## BID ADDENDUM NO. 2

Project: Ogden-Hinckley Airport  
Construct West Apron  
AIP No.: 3-49-0024-066-2025

**(2) PCC PAVEMENT SECTION**  
NOT TO SCALE

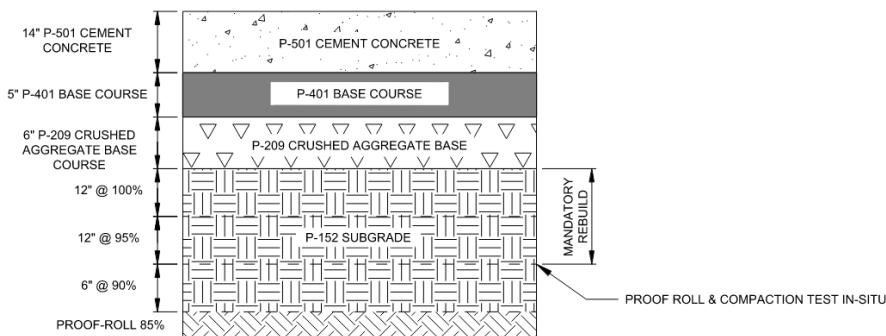
C12. Measurement for the payment of P-152 Embankment is by the square yard per each 12" compaction zone. The intent is that, since an entire 12" section is a mandatory rebuild to meet FAA compaction

requirements, each 12" section is paid for by the square yard. For example, for the section below, for a 100 square yard area, the measurements would be:

P-209 at 6" depth per square yard = 100 SY  
P-152 Subgrade at 100% compaction at 12" depth per square yard = 100 SY  
P-152 Subgrade at 95% Compaction at 12" depth per square yard = 100 SY

Payment would be made as:

P-209-5.1 Crushed Aggregate Base Course, 6-Inch Depth, per SY = 100 SY  
P-152-4.2 Embankment In Place Under Pavement, per SY = 100 SY +100 SY = 200 SY.

1. CONTRACTOR SHALL REBUILD THE 100% AND 95% ZONES. IF IN-SITU SOILS DENSITIES ARE EXCEEDED IN THE 90% ZONE, THAT VOLUME SHALL BE LEFT IN-PLACE.
